Hilcorp Energy Company plans to recomplate the subject well in the Pictured Cliffs formation and downhole commingle the existing Mesaverde and Dakota formations. Attached is the PC C102, recomplate procedure & wellbore schematic. The DHC application will be submitted and approved prior to commingling. A closed loop system will be utilized. Interim reclamation will be performed after surface disturbing activities.

HILCORP ENERGY COMPANY
SAN JUAN 29-6 UNIT 104M
PICTURED CLIFFS RECOMPLETION SUNDRY

Attachment to notice of Intent to Recomplete & Commingle

Well: San Juan 29-6 Unit 104M 30-039-27592

SAN JUAN 29-6 UNIT 104M - CURRENT WELLBORE SCHEMATIC

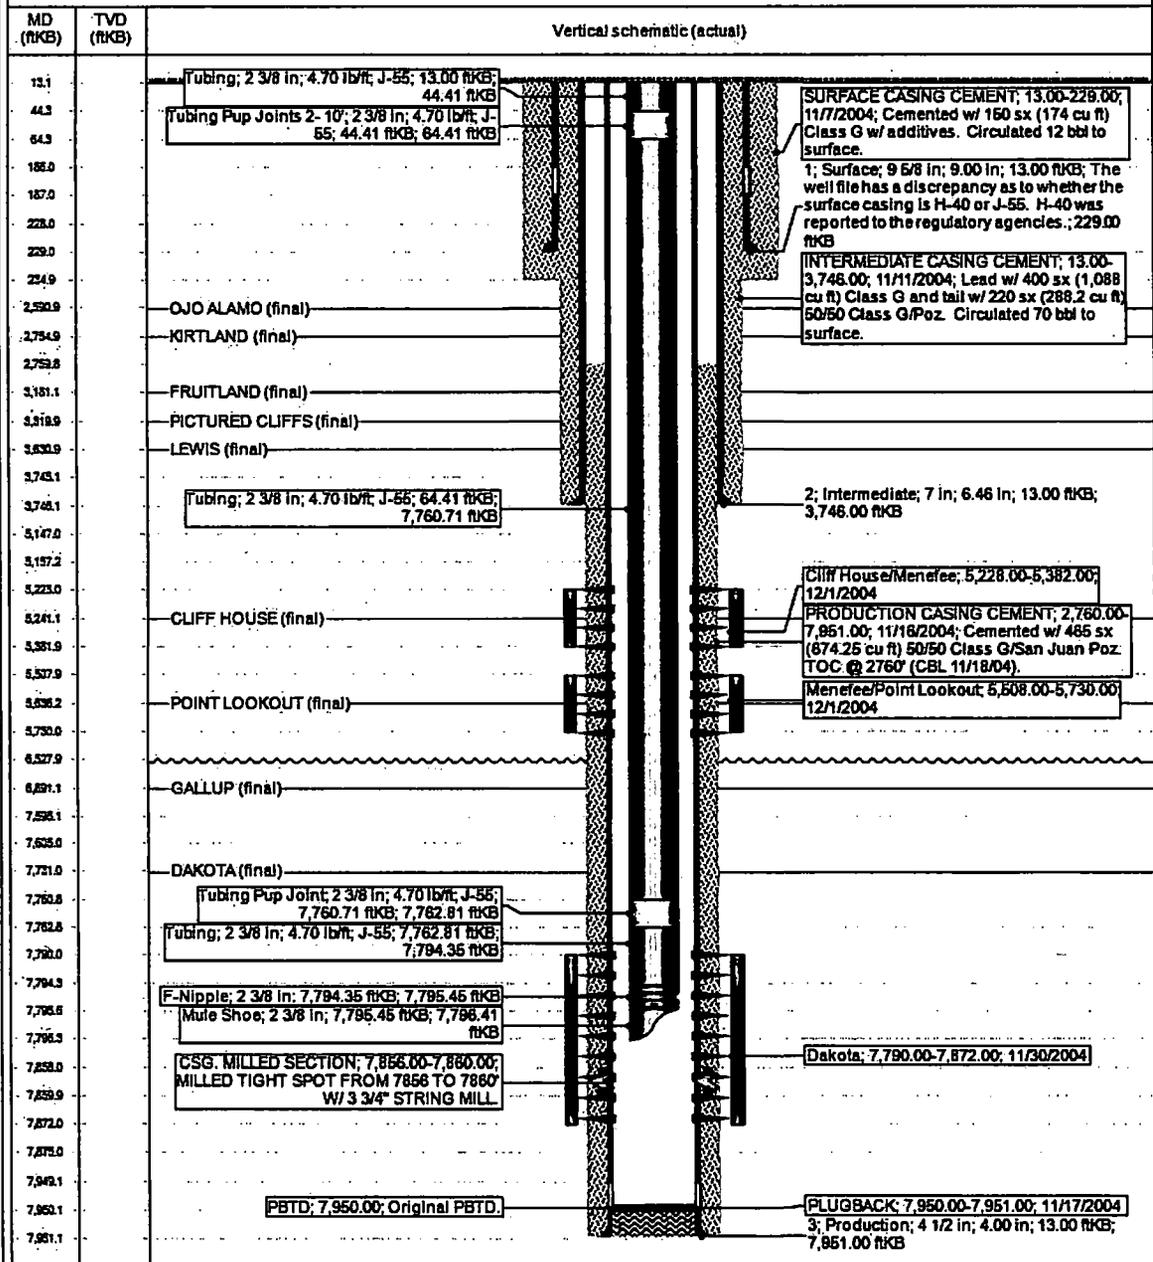
Submit the electronic copy of the MIT Test Chart for verification to the following addresses: jhoffman@BLM.gov and Brandon.Powell@state.nm.us. CBL on file. Good isolation of the PC zone.

2. The following modifications to your recompletion program are to be made:

- a) Upon rigging up, record Bradenhead pressure and monitor same during recompletion operations. Notify BLM and NMOCD if anomalous pressure changes occur. Provide monitoring results in the subsequent Report of Operations.
- b) Casing pressure test for fracture stimulation operations cannot exceed the internal yield strength of the casing including a 20% safety factor unless a waiver is granted. Stimulation operations cannot exceed this test pressure.
